LP Regulator Orientation and Cover

Bulletin Type:	TSB	Publication Date:	October 2025
Bulletin #(s):	25-015	Make(s):	Jayco & Entegra Coach
Job Code(s):	9803637	Model(s):	Seneca XT (29T), Accolade XT (29T)
Flat Rate(s):	9803637A .10 HR – LP Regulator Cover and Orientation Inspection 9803637B 1.0 HR – LP Regulator Cover and Orientation Inspection and Repair	Model Year(s):	2024 - 2025

Incident:	Orientation for LP regulator needs to be changed and cover installed
Affected Units:	2024-2025 Jayco Seneca XT (29T) units; 2024-2025 Entegra Accolade XT (29T) units
Parts Kit: 25-015JM	Parts Kit #: 25-015JM
	Part Kit Contents: 1 - COVER,RGLTR LP STY: UFP ASME TK 1 - BRACKET,LP RGLTR 7.13X6.00 16GA STL BPC 2 - RIVET,PLSTC .63 BLK PLGR 4 - SCREW,HEX WSHR .25X1.00 TEK3 ZC 2 - SCREW,MACH TR QUAD 10-24X .63 ZC 2 - NUT,HEX KEPS 10-24 ZC
Misc. Tools & Supplies:	Screw Gun with 3/8" Drive head & Square Head Bit, 1/2" wrench, 1" hole saw
Parts Return Information:	N/A

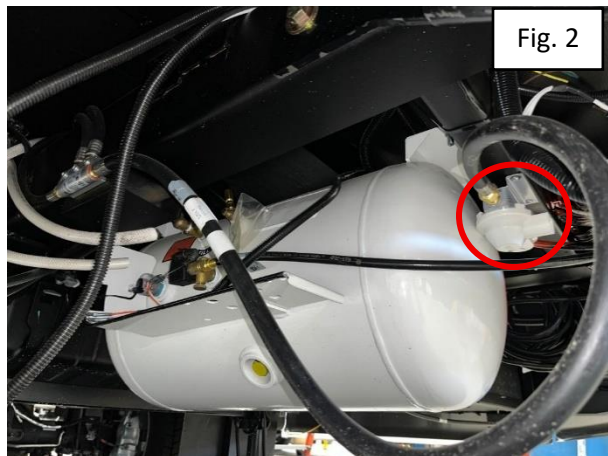
1. Locate the LP regulator under the coach near the LP Tank. (Figure 1)

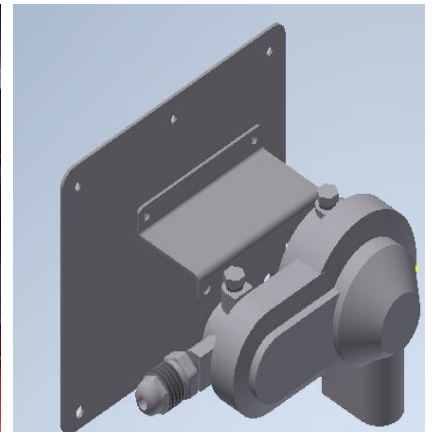
2. Remove the regulator and bracket from the coach using a screw gun with a square head bit. (Figure 2)

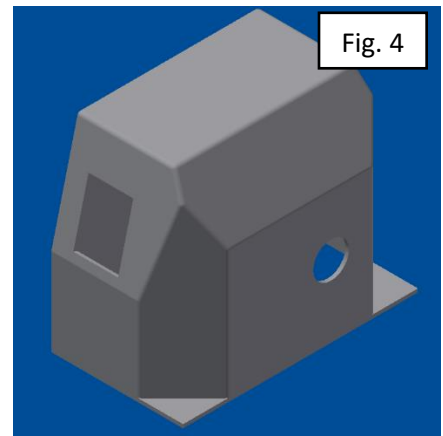
3. Disconnect the supply hose from the regulator using a 1/2" wrench.
4. Attach the regulator and bracket to the new mounting bracket using the supplied machine screws and washers. (Figure 3)
 - a. **Note: It is CRITICAL that the regulator vent be facing downwards.**

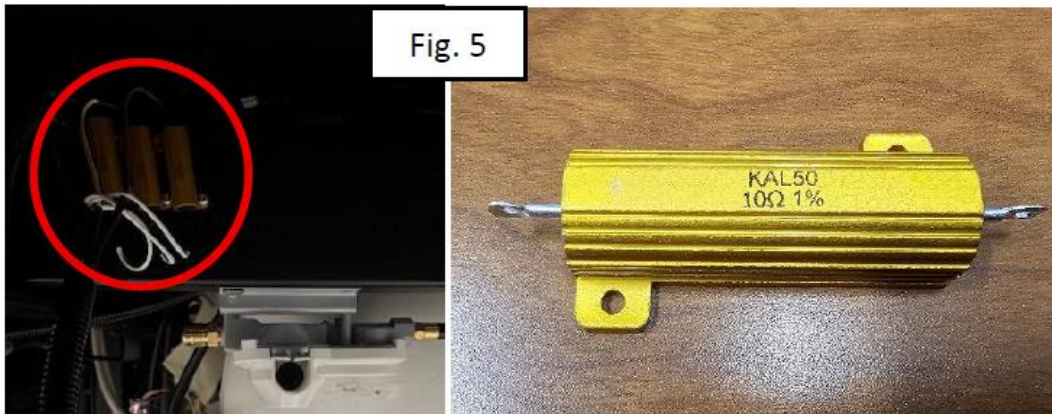
5. Place the new cover over the regulator and mark the location of the regulator vent. Use a 1" hole saw to cut a 1" hole in the cover for the regulator vent. (Figure 4)

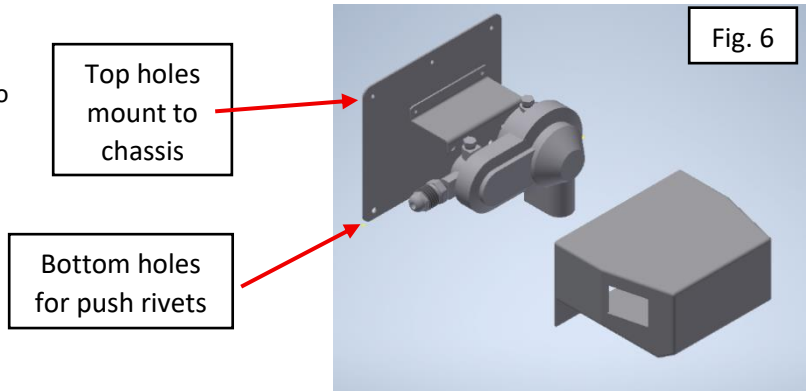
6. Re-install the bracket and assembly onto the coach, without the cover.
 - a. Note: There may be resistors on the frame rail where the LP Regulator will be mounted. (Figure 5) In the event the coach has the resistors in this location, route the LP lines away from the resistors. Contact Jayco Motorized Service for additional assistance.

7. Attach the cover to the new mounting plate over the regulator. Secure it to the bracket using the supplied push rivets (X2). (Figure 6)
